OLD COLONY ATTN: EDITORIAL

DATE 6/1/93

I have encountered a design flaw in the A75 amplifier which can result in damage to the front end transistors. Under conditions of hard clipping, the gate to source voltages of Q9 and Q10 can experience transients which exceed the manufacturer's recommendations.

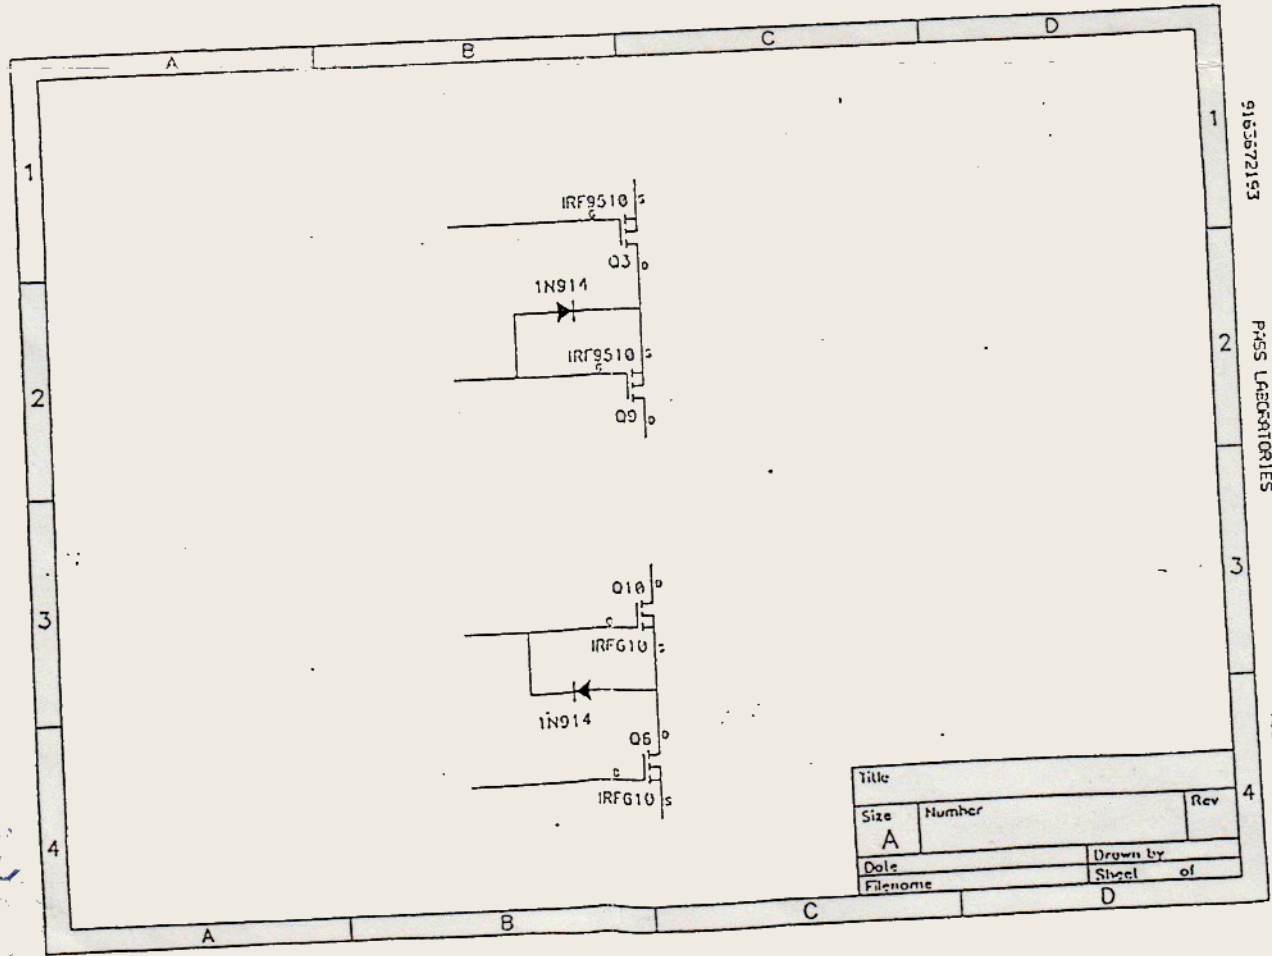
During clipping, Q3 and Q6 can be seen to shut off briefly, and this leaves the source connections of Q9 and Q10 open, allowing the leakage current through Q9 and Q10 to briefly pull the source voltage toward the drain's potential.

In a small percentage of the amplifiers this transient will punch through the gate oxide of the transistors and result in failure.

To prevent this, signal diodes such as 1N914 or 1N4148 must be installed between the gate to source connection on Q9 and Q10 as shown in the accompanying diagram. Normally these diodes will be reverse biased, but they will become forward biased during the transient, protecting the gate.
